**Subject:** San Mateo Park Elementary School HVAC Replacement  
San Mateo - Foster City School District  
Aedis Project No. 2021011.08  
DSA Application #01-120214

### ADDENDUM NO. 1

San Mateo Park Elementary School HVAC Replacement  
San Mateo – Foster City School District  
Aedis Project No. 2021011.08

SHEET

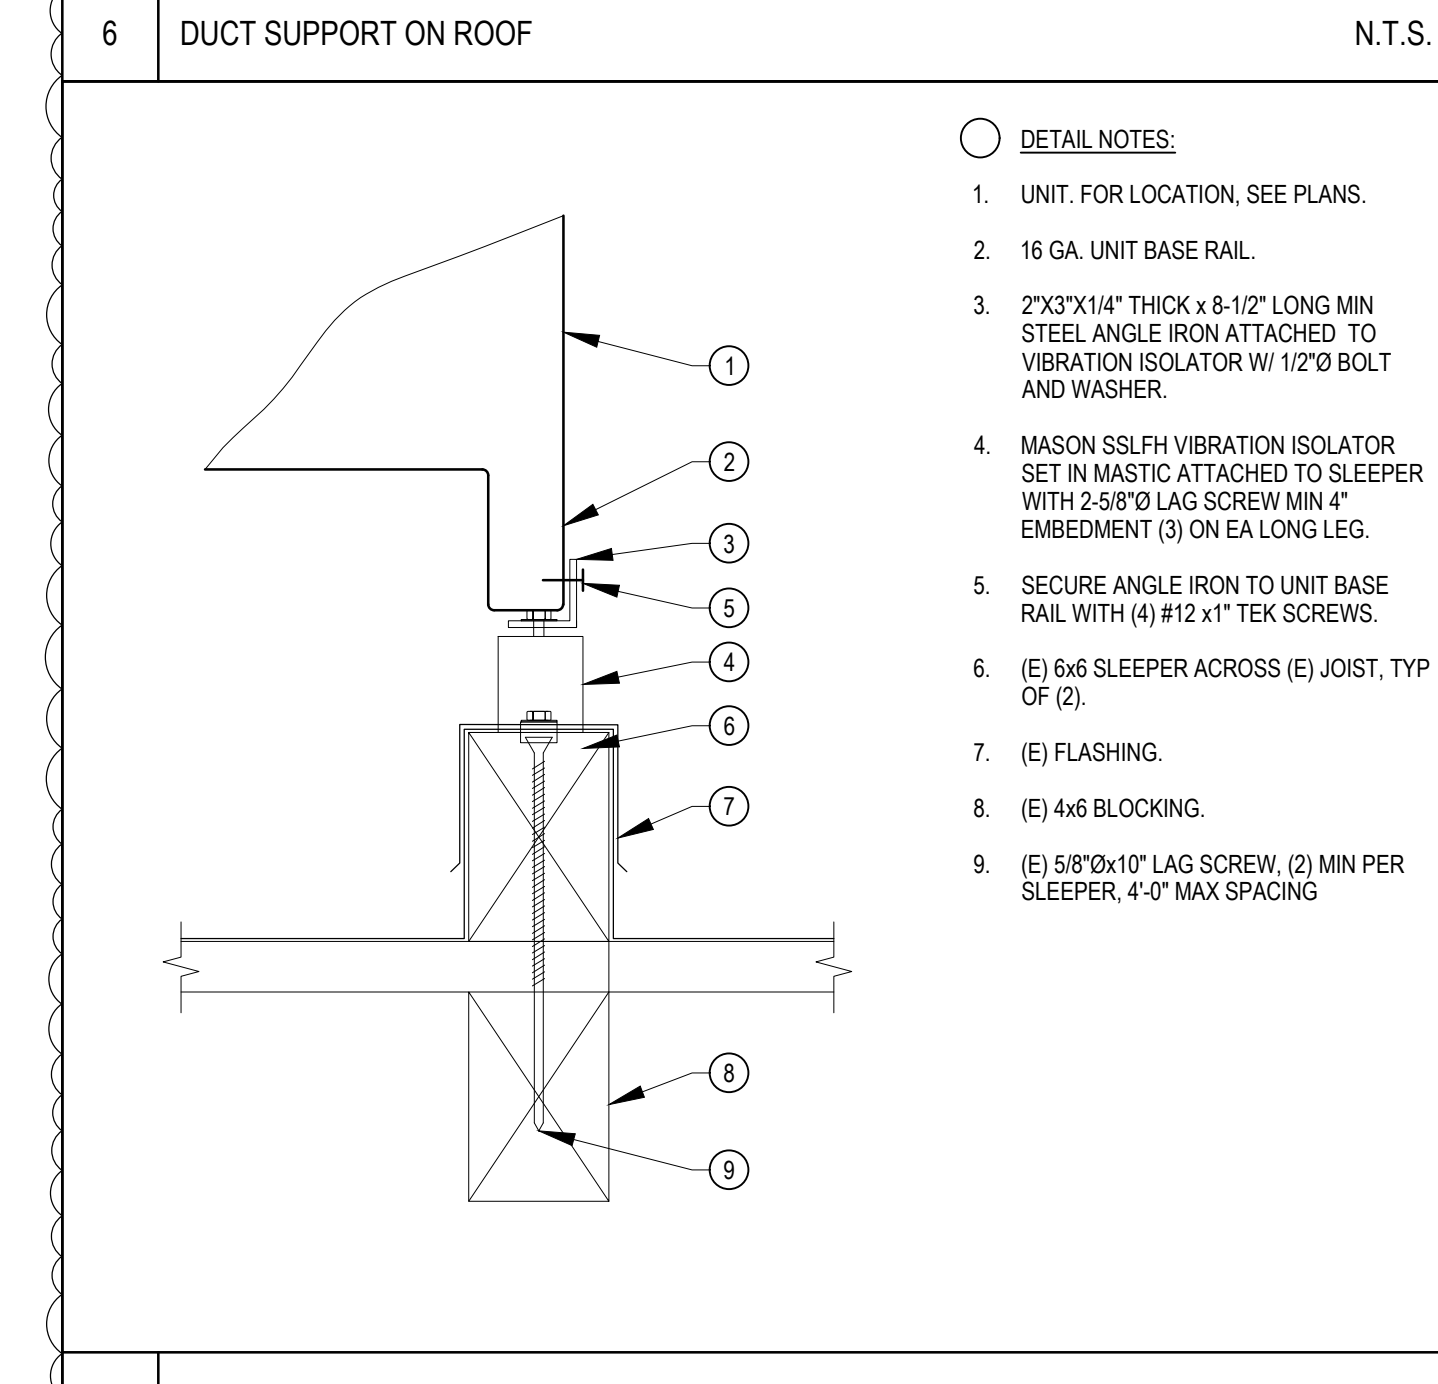
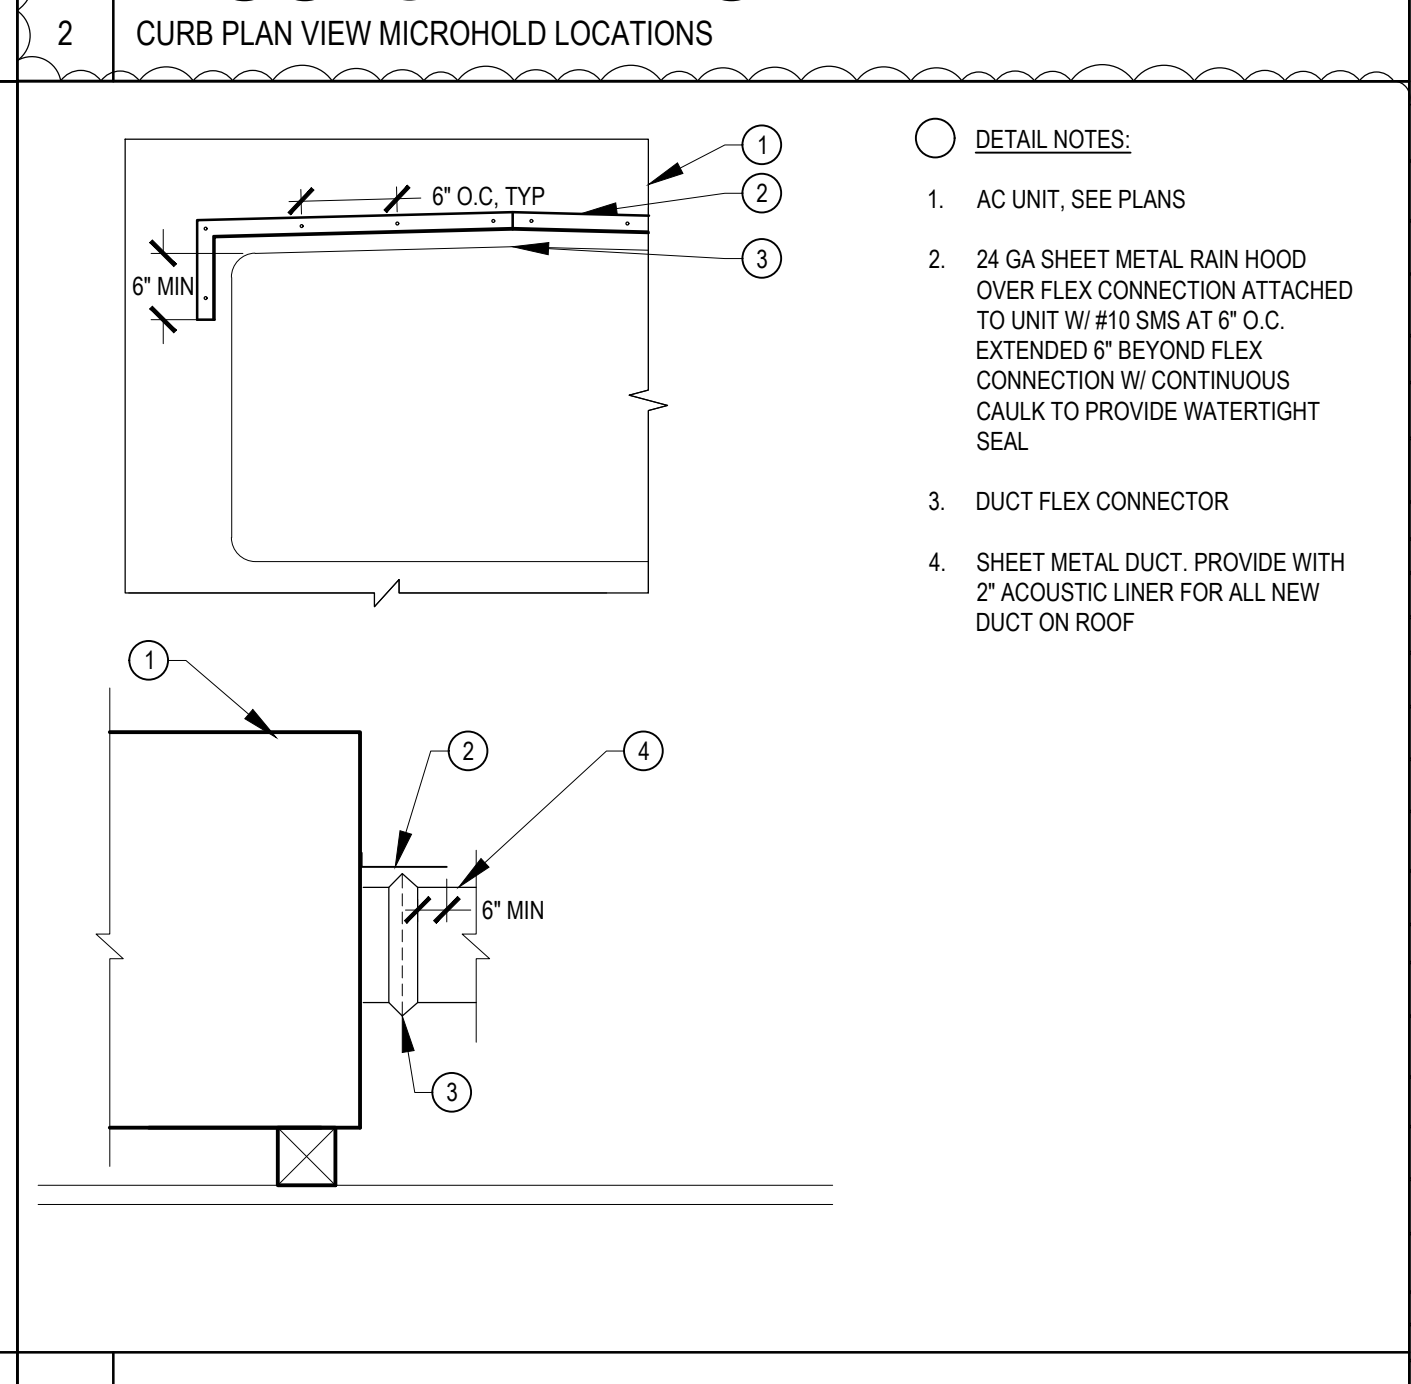
- Revise: Detail 2 – Curb Plan View Microhold Locations as shown per AD1-MP6.02
- Add: Details 3 through 7 as shown per AD1-MP6.02
